Contract #: 04-0120F4  
 Cty: SF/ALA Rte: 80 PM: 13.2/13.9  
 File #: 69.25B

**QUALITY ASSURANCE -- NON-CONFORMANCE REPORT**

**Location:** Changxing Island, Shanghai, PRC **Report No:** NCR-000403  
**Prime Contractor:** American Bridge/Fluor Enterprises, a JV **Date:** 10-Sep-2009  
**Submitting Contractor:** Zhenhua Port Machinery Company, Ltd (ZPMC), Changxing Island **NCR #:** ZPMC-0377

**Reference Description:** Missed MT indications on South Tower, Lift 1, Skin A & B Pad Eyes

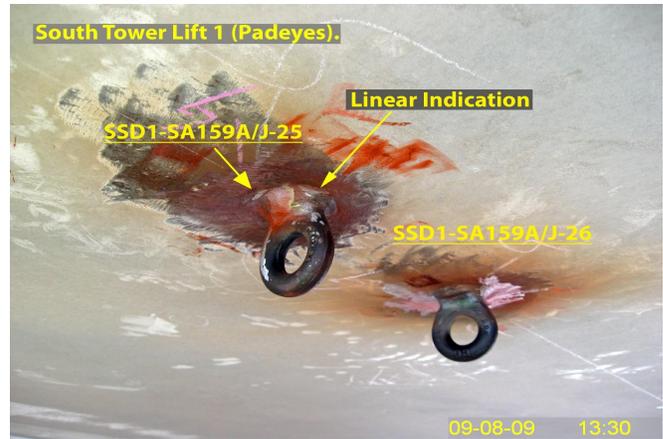
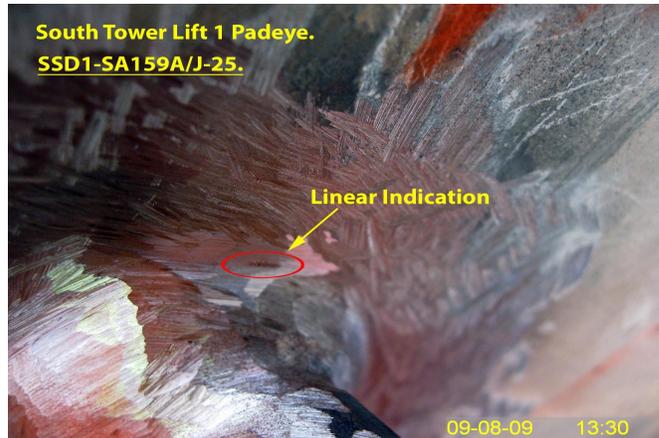
During Magnetic Particle Testing (MT) of South Tower, Lift 1, Skin A pad eyes, QA observed linear indications at weld joints SSD1-SA159A/J-25 & SSD1-SA159A/J-28. ZPMC MT Technicians had previously tested and accepted 10% of the pad eye welds. After QA found the linear indications, ZPMC QC personnel Zhang Jiadi asked to cancel the request for QA inspection in order to perform 100% MT of remaining pad eyes.

Following ZPMC's testing and acceptance of 100% of the pad eye welds, QA performed MT and discovered linear indications at weld joints SSD1-SA159A/J-24 & SSD1-SA178A/D-35.

**Reference Description:** Missed MT indications on South Tower, Lift 3, Skin A Padeyes

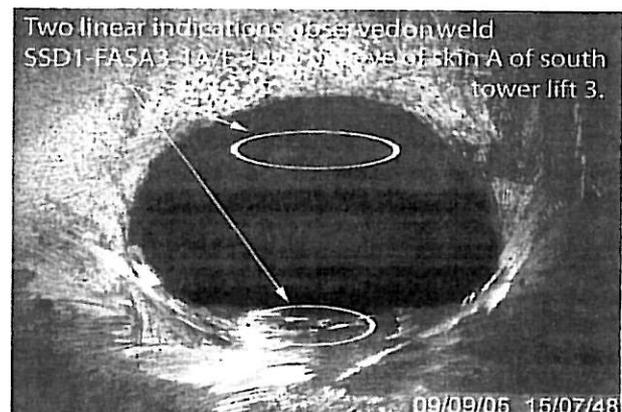
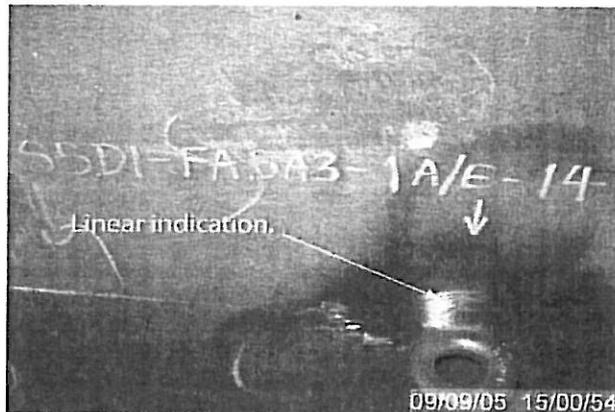
During Magnetic Particle Testing (MT) of South Tower, Lift 3, Padeye weld SSD1-FASA3-1A/E-14, QA discovered two linear indications approximately 15 and 12mm in length. This weld was previously tested and accepted by ZPMC NDT personnel.

WELD NUMBER:SSD1-FASA3-1A/E-14

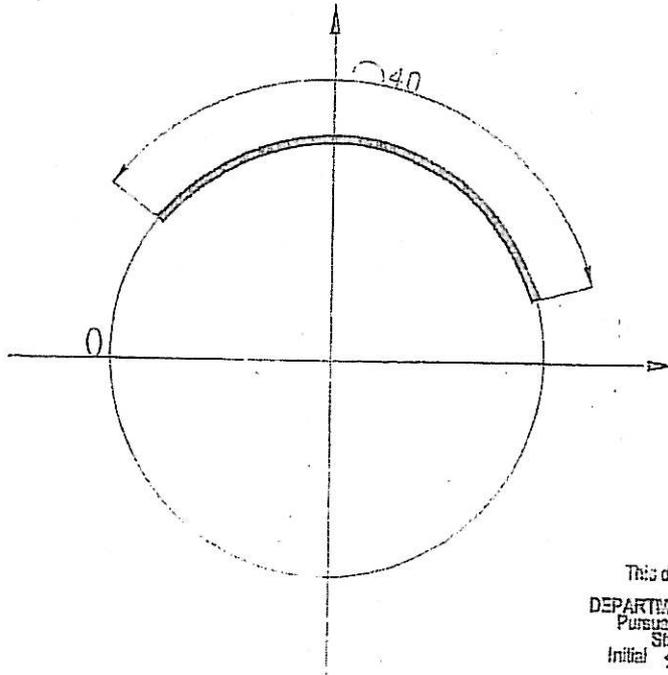
在对SSD1-FASA3-1A/E-14检测时, 发现1处线性缺陷。

One line indication was found by use of MT on SSD1-FASA3-1A/E-14.

1. 火焰加热时, 水汽没有完全的去掉或者这个区域预热不够;
1. Moisture wasn't completely removed during drying operation (preheating) or the area wasn't preheated sufficiently.

1. QC shall monitor and direct the welder and the grinder doing the repair operation.
  2. Preheat before gouging; the temperature shall be at least 65°C.

3. Gouge the weld to remove identified defects.
  4. Joint details shall refer to the approved WPS repair.
  5. Grind the gouged areas to a smooth and shiny surface.

6. Verify with VT and MT to ensure no defects remain in the weld joint prior to welding.
  7. QC shall monitor all welding passes being deposited.
  8. QC shall ensure all slag has been removed prior the deposition of next pass.

9. Preheat and maintain interpass temperature control in accordance with the WPS.
  10. Blend the weld repaired areas into the adjacent weld or base metal by grinding.

11. Perform VT, MT and UT NDT inspection to the repaired areas.
1. 在返修过程中, QC 应该监控和指导焊工和打磨工;
  2. 碳刨之前必须先进行预热, 温度不低于 65°C;
  3. 碳刨去除缺陷;
  4. 缺陷被完全消除后, 必须准备一个正确的接头型式, 具体接头型式请参见对应的修补焊接工艺规程(WPS);

**Reference Description:** Missed MT indications on South Tower, Lift 1, Skin A & B Pad Eyes

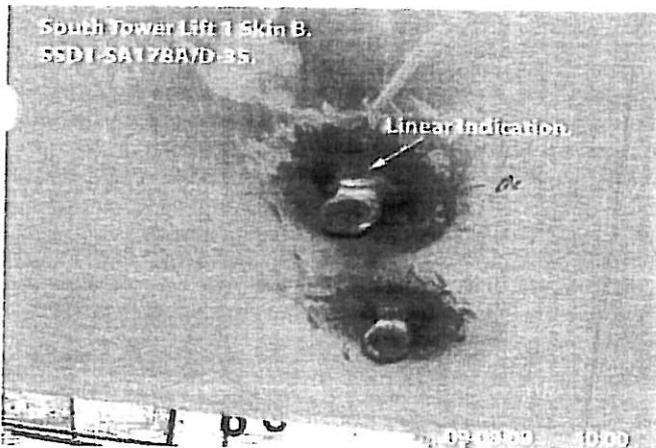
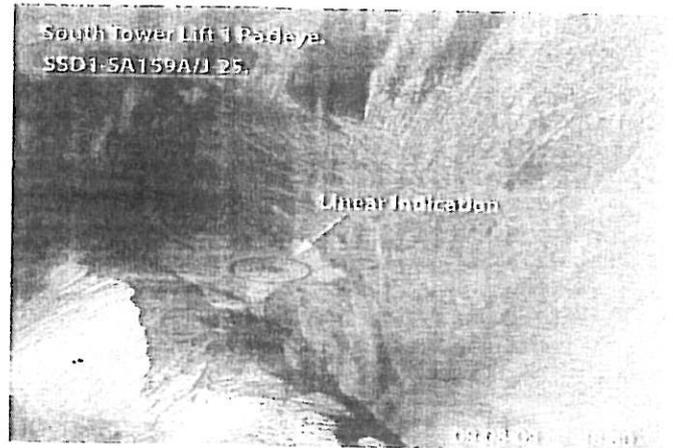
During Magnetic Particle Testing (MT) of South Tower, Lift 1, Skin A pad eyes, QA observed linear indications at weld joints SSD1-SA159A/J-25 & SSD1-SA159A/J-28. ZPMC MT Technicians had previously tested and accepted 10% of the pad eye welds. After QA found the linear indications, ZPMC QC personnel Zhang Jiadi asked to cancel the request for QA inspection in order to perform 100% MT of remaining pad eyes.

Following ZPMC's testing and acceptance of 100% of the pad eye welds, QA performed MT and discovered linear indications at weld joints SSD1-SA159A/J-24 & SSD1-SA178A/D-35.

Tower(S) first lifting, the cracks were found on three lifting ring on Skin A and one lifting on Skin B, weld ID : Skin A:SSD1-SA159B/J-24, 25, 28, Skin B SSD1-SA178A/D-35.

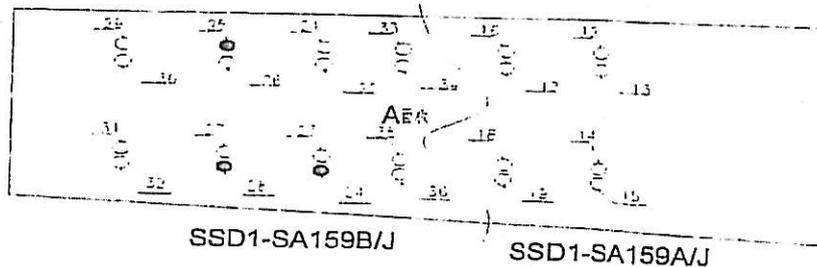
南塔一吊A面3个吊环B面1个吊环MT后发现裂纹:

A面: SSD1-SA159B/J-24, 25, 28

B面: SSD1-SA178A/D-35

1. 火焰加热时, 水汽没有完全的去除或者这个区域预热不够;
1. Moisture wasn't completely removed during drying operation (preheating) or the area wasn't preheated sufficiently.

3. QC shall monitor and direct the welder and the grinder doing the repair operation.
  4. Preheat before gouging; the temperature shall be at least 65°C.

5. Gouge the weld to remove identified defects.
  6. Joint details shall refer to the approved WPS repair.
  7. Grind the gouged areas to a smooth and shiny surface.

8. Verify with VT and MT to ensure no defects remain in the weld joint prior to welding.
  9. QC shall monitor all welding passes being deposited.
  10. QC shall ensure all slag has been removed prior the deposition of next pass.

11. Preheat and maintain interpass temperature control in accordance with the WPS.
  12. Blend the weld repaired areas into the adjacent weld or base metal by grinding.

13. Perform VT, MT inspection to the repaired areas.
1. 在返修过程中, QC 应该监控和指导焊工和打磨工;
  2. 碳刨之前必须先进行预热, 温度不低于 65° C;
  3. 碳刨去除缺陷;
  4. 缺陷被完全消除后, 必须准备一个正确的接头型式, 具体接头型式请参见对应的修补焊接工艺规程(WPS);
